BHP Billiton Diamonds Inc.

Wek'eezhii Land and Water Board
#1, 4905 – 48th Street
Yellowknife, NT
X1A 3S3

**Re: Updated Wastewater and Processed Kimberlite Management Plan (WPKMP),
ENVR-SWP-PKWW-05, Water Licences MV2003L2-0013 and MV2001L2-0008**

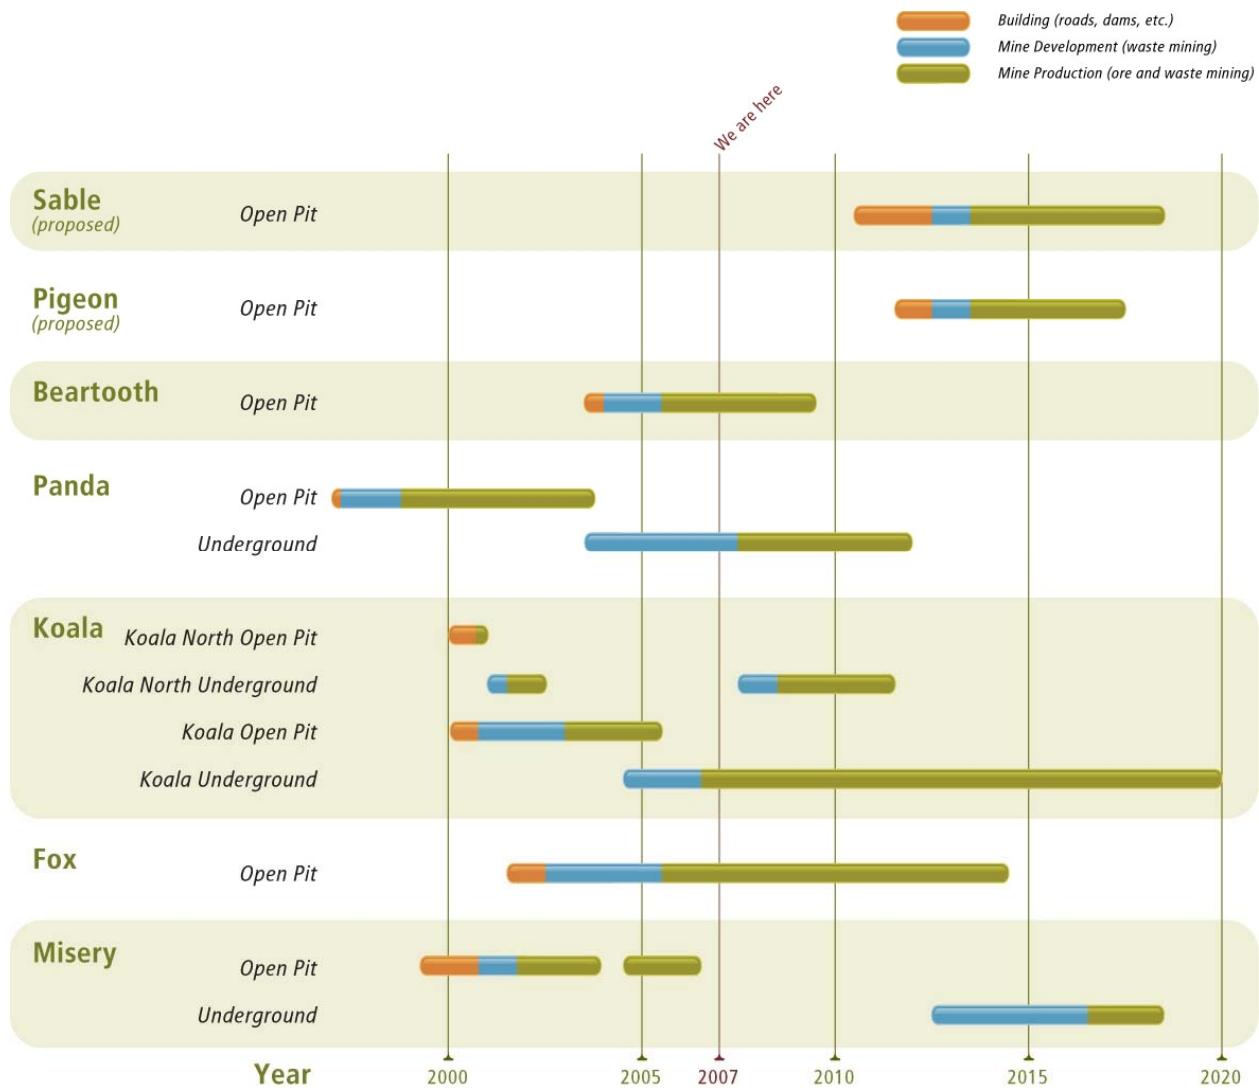
b) Include the Life of Mine Plan.

The current Life of Mine plan is included in Section 1.1 on page 7 of 88 of the updated WPKMP. The current Life of Mine plan (also shown below) includes the mining of the Fox Pit, Beartooth Pit, Panda Underground, Koala Underground and the sequential development of Koala North Underground, Sable Pit, Pigeon Pit and Misery.

The Life of Mine plan shows the current approach to full and responsible utilization of mineral resources. This is a flexible, living document which continually changes with many outside factors and is therefore subject to continual change over the tenure of the WPKMP and to the expected end of mining in 2020. Some of the factors that may change the Life of Mine plan, for example, include exploration of additional kimberlite pipes, economic factors and other conditions.
